# SAN FRANCISCO PLANNING DEPARTMENT

**MEMO**

**RE:** Review and Comment for 1 Stockton Street  
Case No. 2015-014090PTA

prepared for: **T-Mobile**  
**San Francisco Store Signature**  
**Exterior Design**  
March 4, 2016

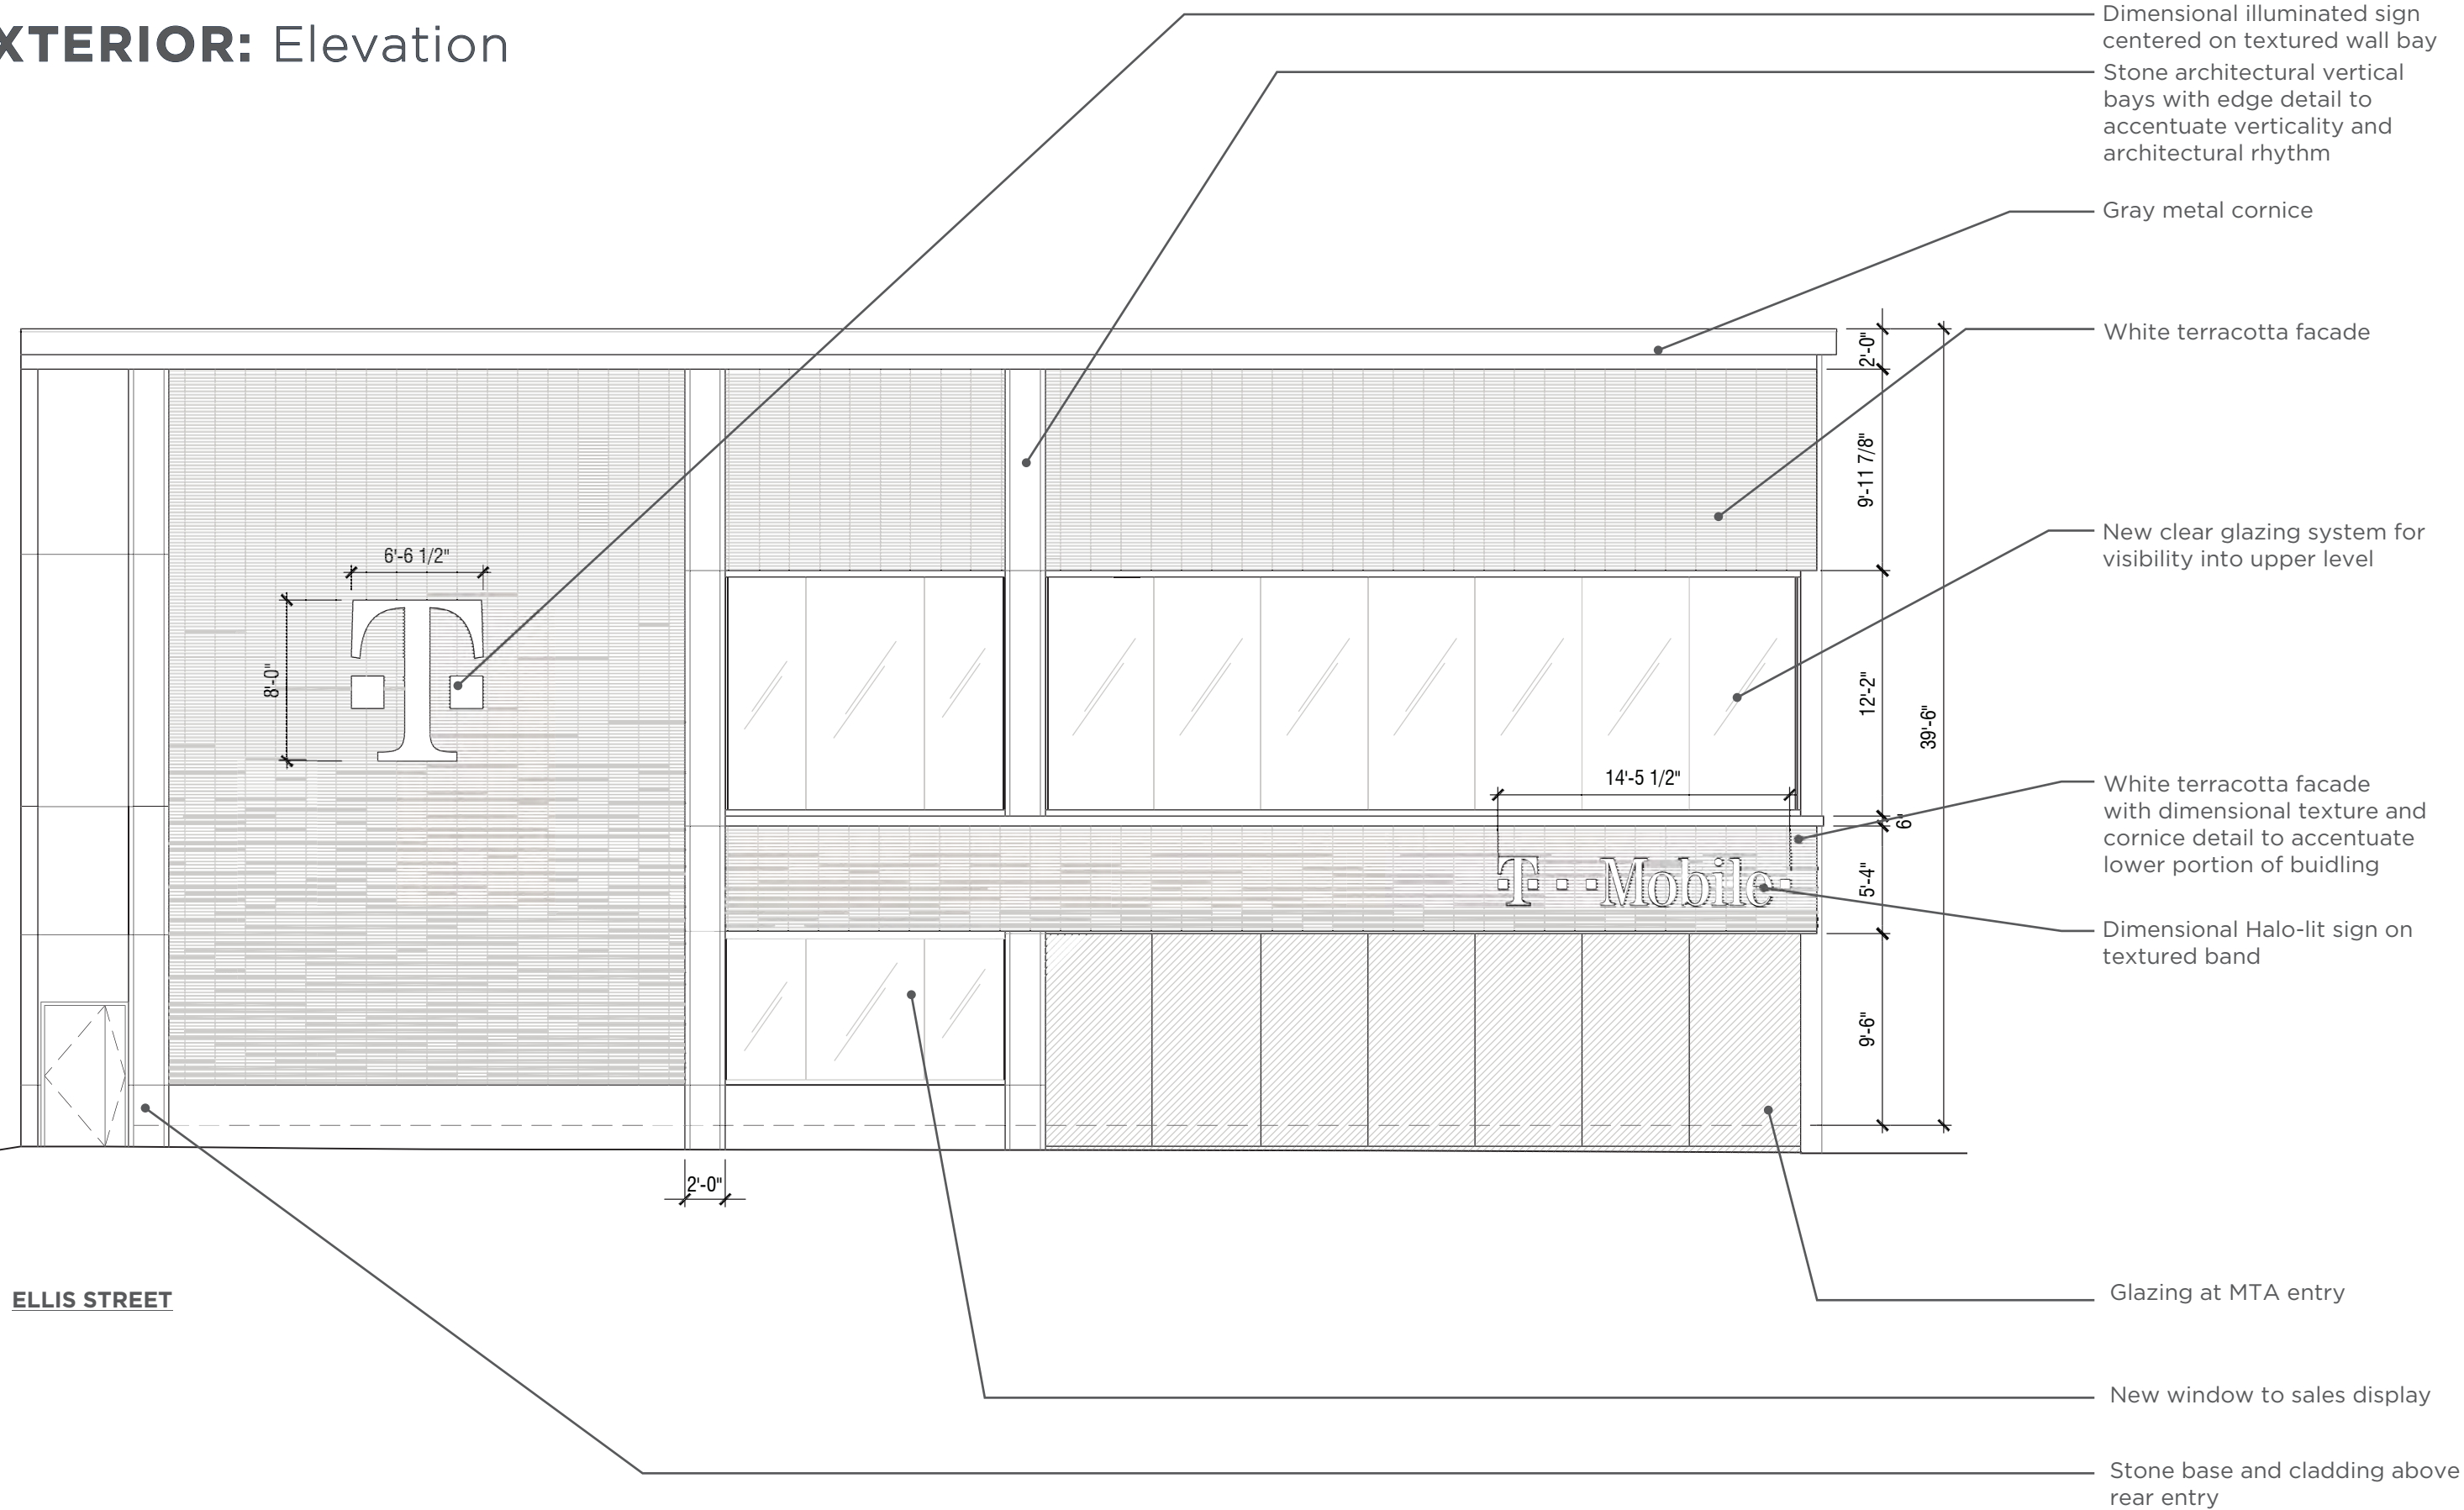
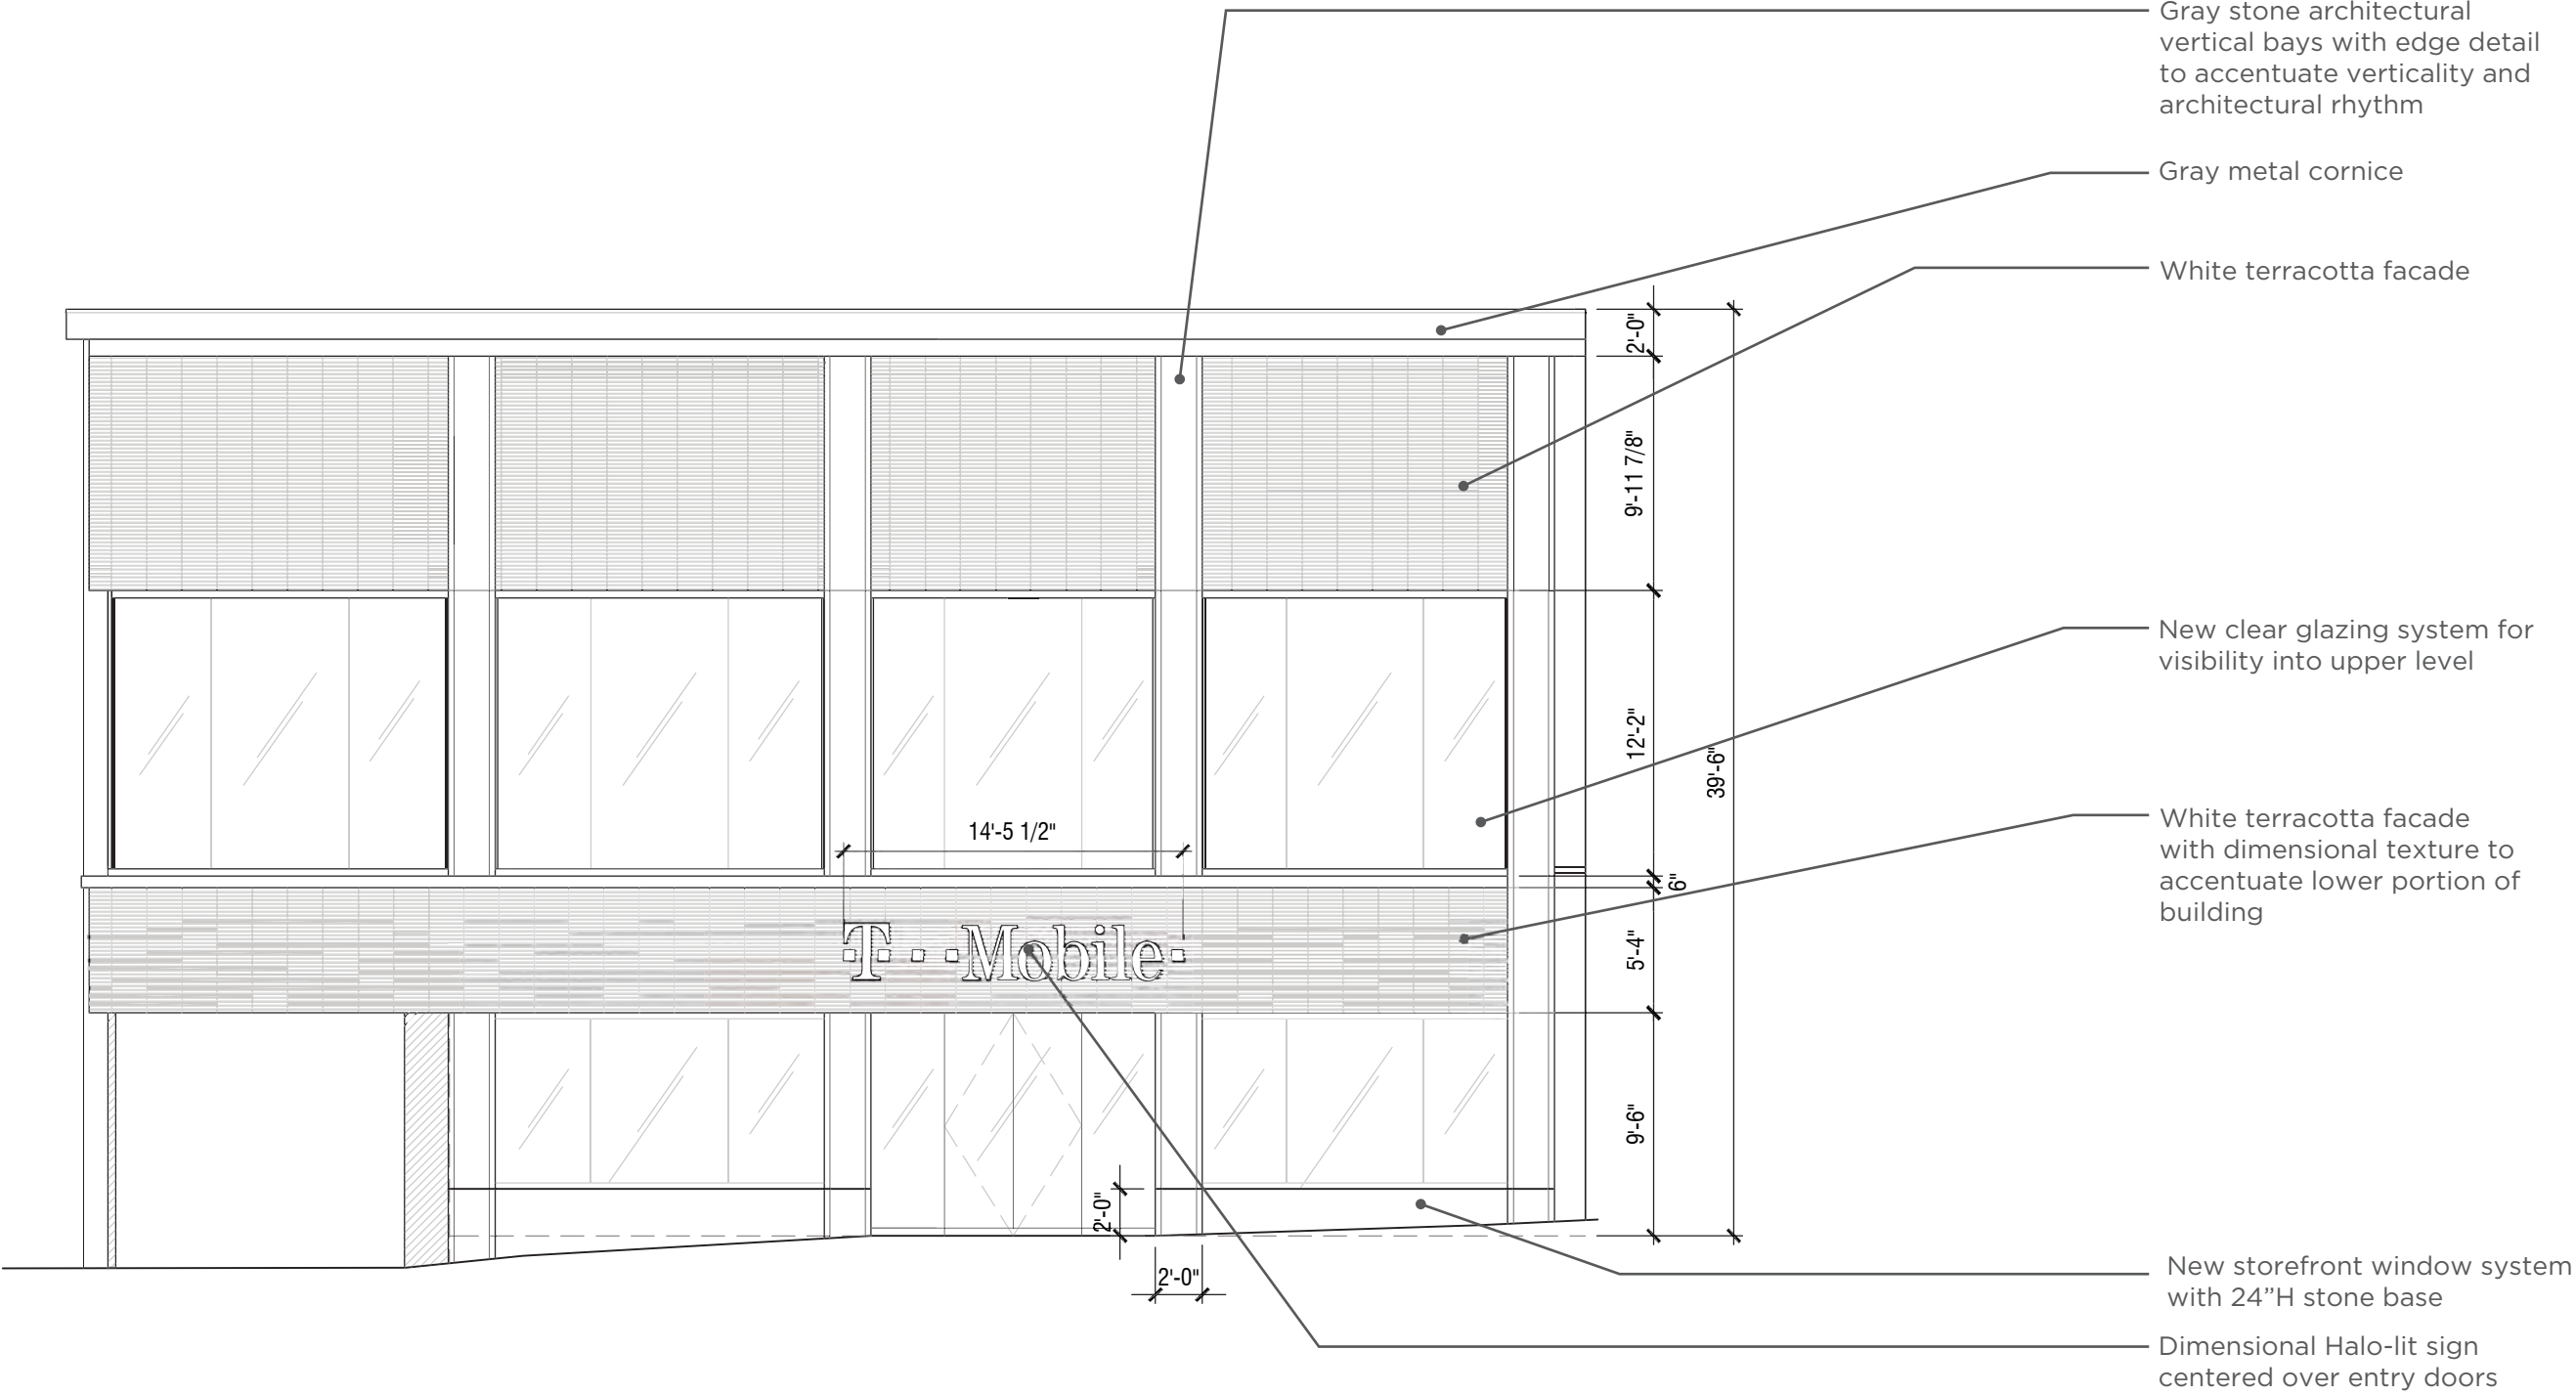
*The project sponsor has provided two versions of the façade for discussion: in Option A, the horizontal spandrel between floor levels is continuous, breaking the vertical piers into two parts; in Option B, the vertical piers extend the height of the building, breaking the horizontal spandrel into segments.*

*Both options address issues of compatibility with the District. Option A, with the continuous spandrel, emphasizes the two-part vertical composition and more clearly delineates the building base, but it also diminishes the vertical expression of the façade bays, which is also an important characteristic of the District, particularly on a building of this size. Option B, with the continuous vertical piers, creates a fenestration pattern consistent with the District and reinforces the vertical expression of the façade, but deemphasizes the horizontal spandrel and two-part composition. Although the horizontal break is important, the vertical expression provided by Option B appears to be most compatible with the massing and composition of buildings in the District. Further, the continuous vertical piers anchor the base of the building.*

- *The Department would like the ARC to provide guidance regarding the two options for the façade design. Both options offer approaches to address compatibility with massing and composition of buildings within the District. The Department believes that Option B, which maintains the continuous vertical piers, is more consistent with the District, as it provides vertical expression on an otherwise low-slung building.*
